Addendum 1 for RFB927940-04

Project Name: WRC Decentralization Phase 4 & Fire Alarm Phase 3 (9279.40 & 9279.41) Bid Issuance #4
DAS RFB #: 927940-04
DAS Project #: 9279.40 & 9279.41
Date: 5/21/2026

CHANGES TO DRAWINGS

A4 HEAT PUMP CONTROL SEQUENCE
NOT TO SCALE

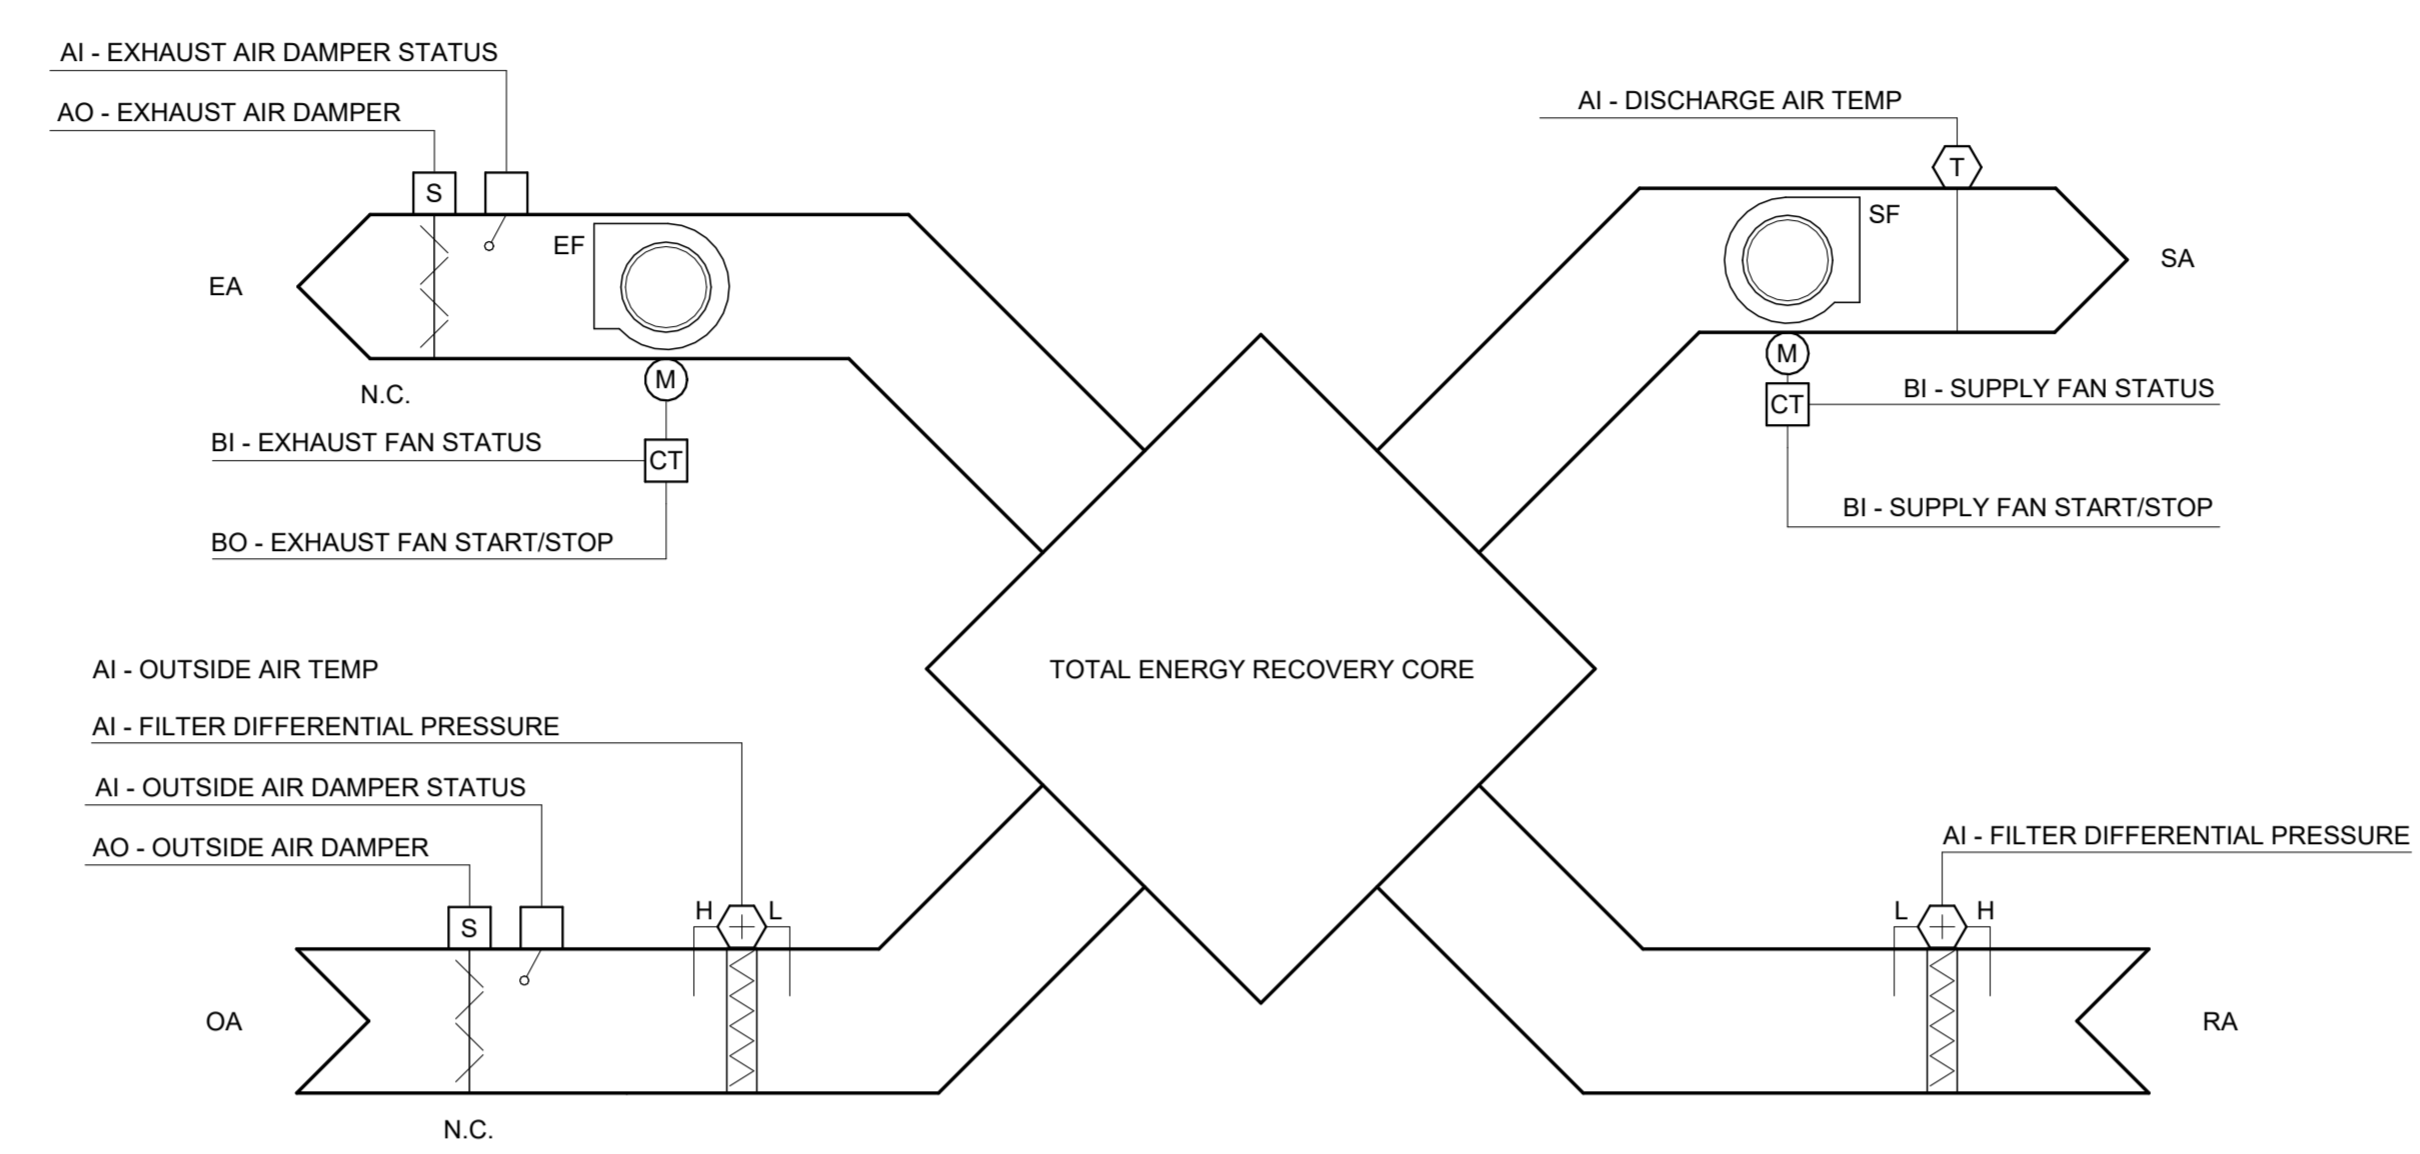
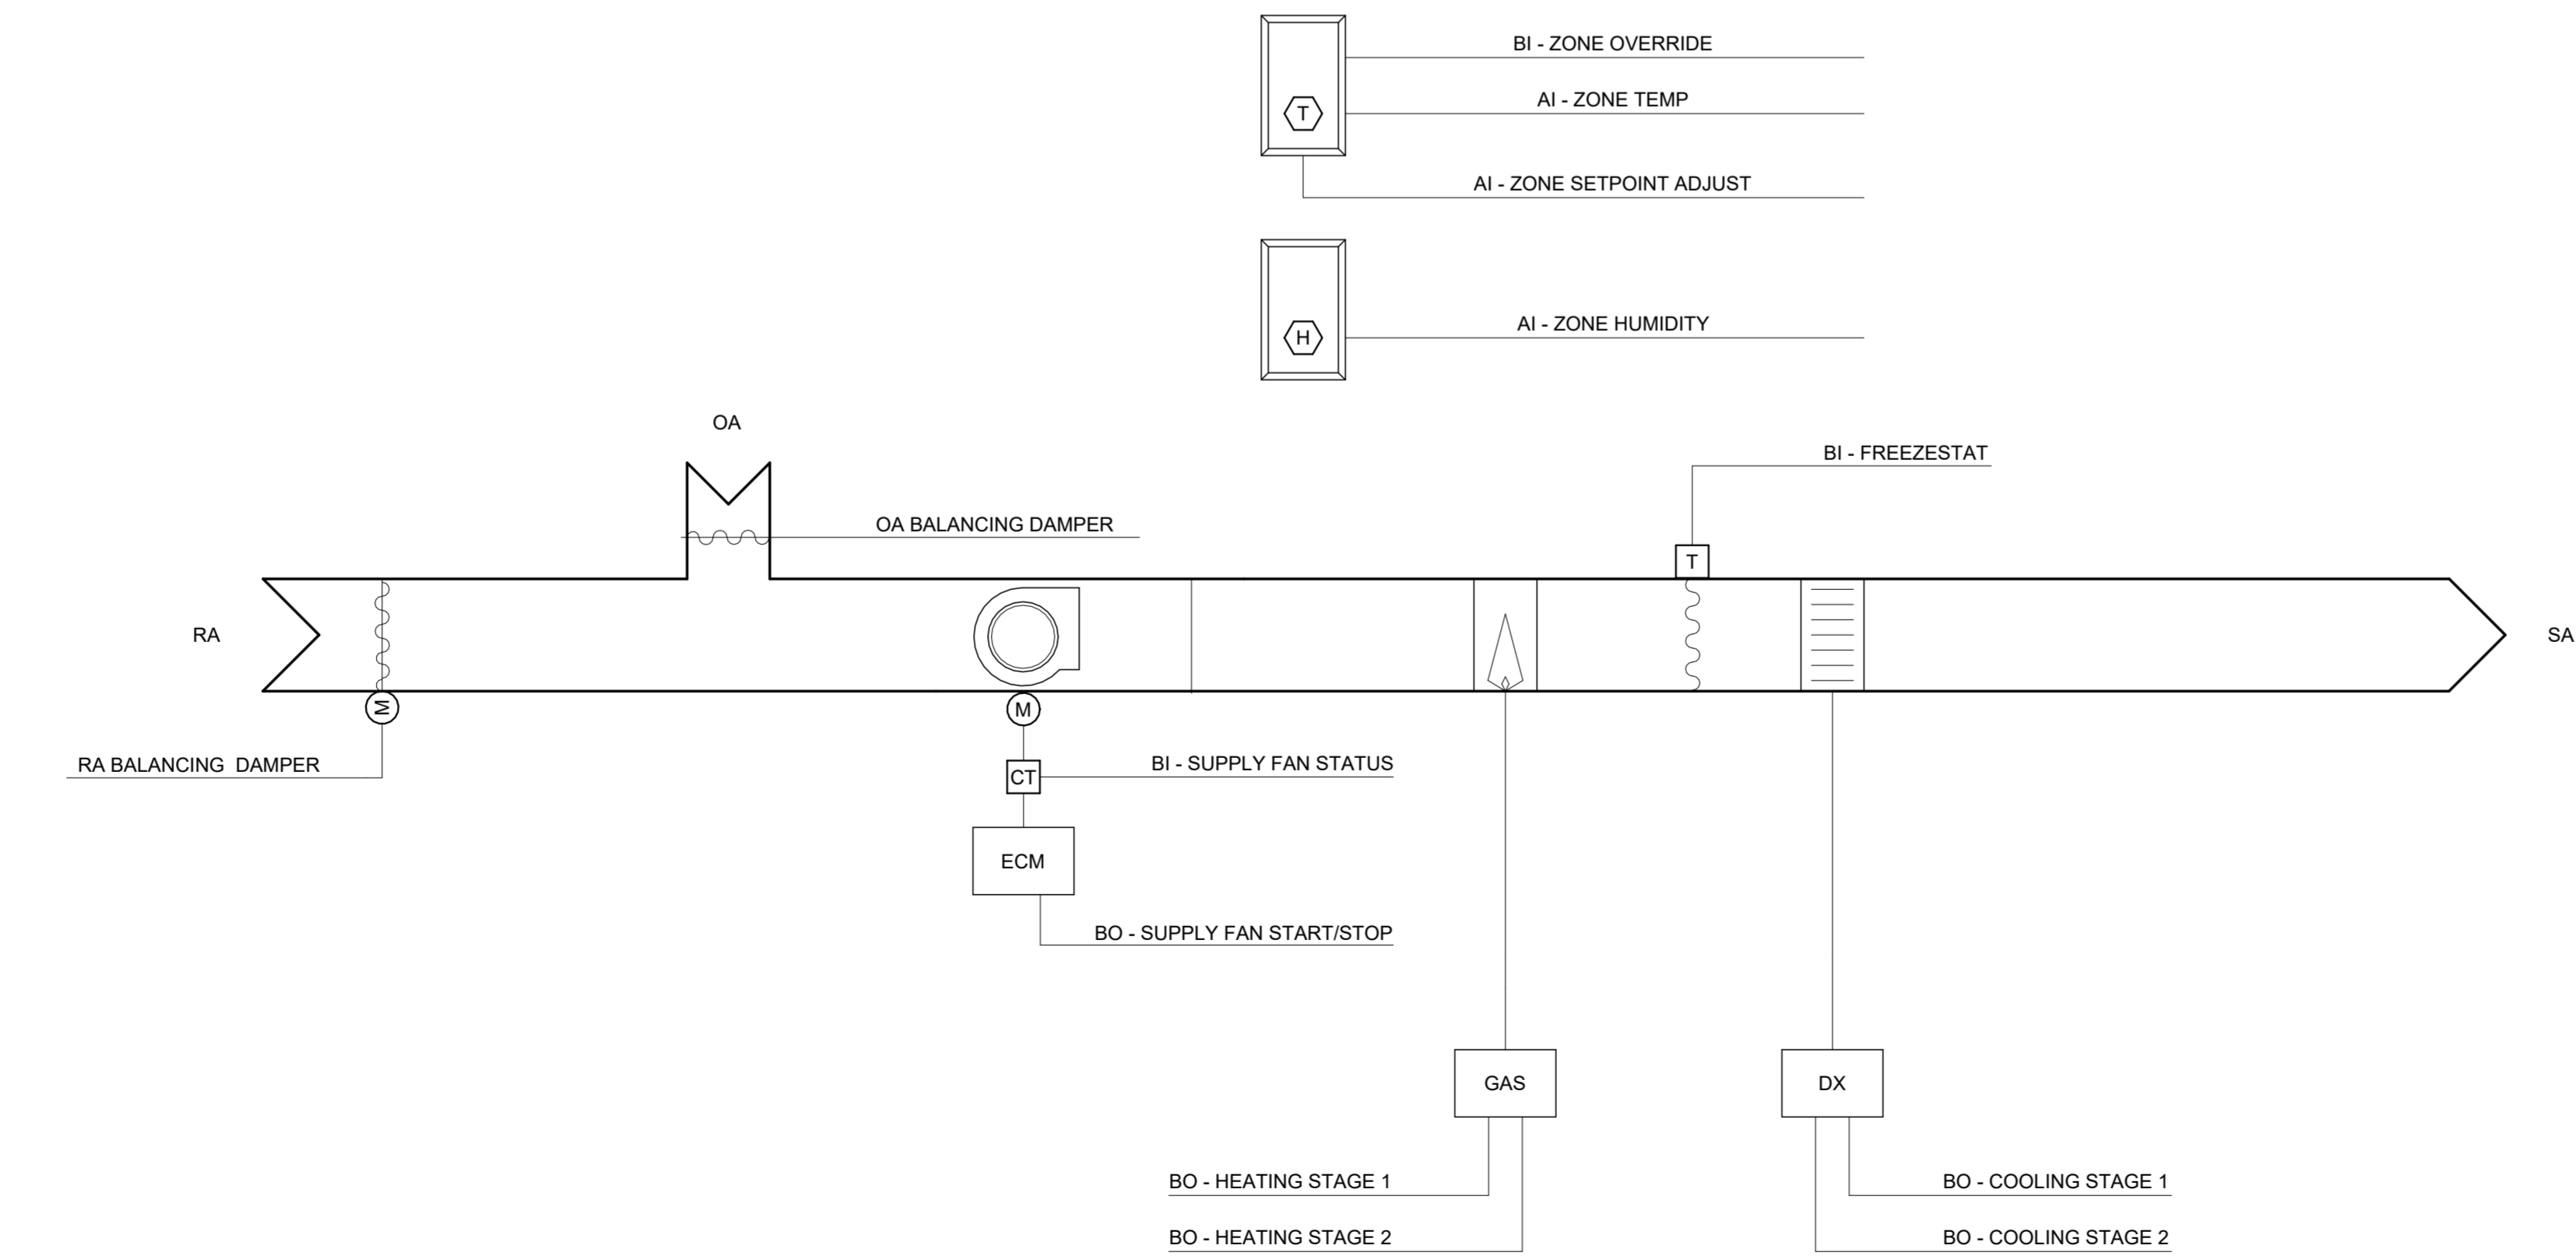
- **ADD** Keynote 13-M32
- **13-M300 – THERMOSTAT PLAN:**
 - **REVISE** thermostats in Area D Basement.
- **13-M501 –MECHANICAL CONTROLS:**
 - **ADD** ERV control sequence.

- **ADD** heat pump control sequence.
- **13-M600 –MECHANICAL SCHEDULES:**
 - **REVISE** ERV schedule.
